UNITED STATES PATENT AND TRADEMARK OFFICE

Office Action Summary

10/758,364

DETAILED ACTION

FIGURE A: From Figure 2 of Pelka, modified to indicate the light distribution surface and sidewalls

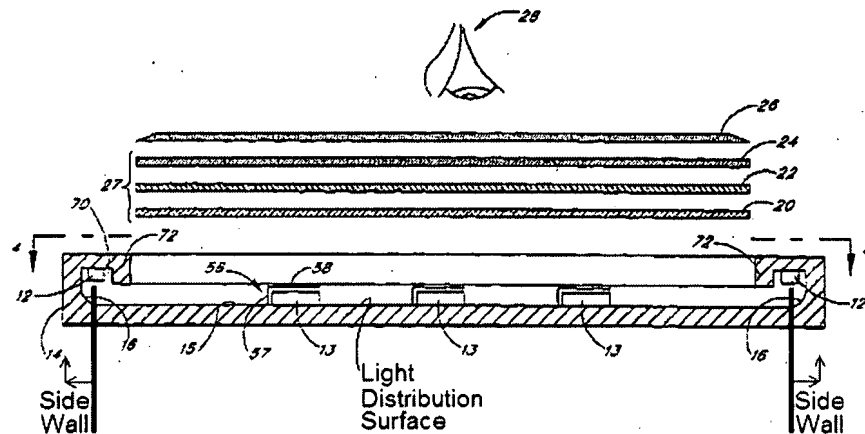
1. Applicant's arguments filed 28 June 2007 regarding the rejection of claims 1-11 under 35 U.S. C. §102(b) as being anticipated by Pelka (US 6,007,209) have been fully considered but they are not persuasive. Applicant argues that Pelka fails to disclose the claimed invention because area 'S', as defined by the instant application, does not constitute the entire bottom surface of the illumination device and that Pelka's "area 'S'" should be determined by considering the area where the light sources are actually mounted." The Examiner respectfully disagrees. The claim, as currently amended, states: "a plurality of light sources distributed on a plane with a light distribution surface area 'S'. The Examiner interprets the "light distribution surface" as a surface that will assist in the distribution of the light emitted by the light sources to the optical devices of the LCD. The Examiner further interprets the bottom surface 15 as the light distribution surface since the surface has a reflective coating to assist in delivering the light emitted by the light sources to the optical devices positioned above the surface. For assistance, the Examiner has provided a copy of figure 3 of Pelka, which has been modified to indicate the area of the bottom surface considered to be the light distribution surface and where it turns into the side walls below.

As indicated in figure A above, the light distribution surface area 'S' is greater than the area of the light incident area of the diffusing plate.

a plurality of light sources [12, 13] distributed in a plane over an area 'S' [indicated above].

least one light-diffusing plate [figure 4 shows the array and the area 'S' in which the lights are disposed; figure 3 shows the size of the area in relation to the light incidence area of the light-diffusing plate; figure A above]; and
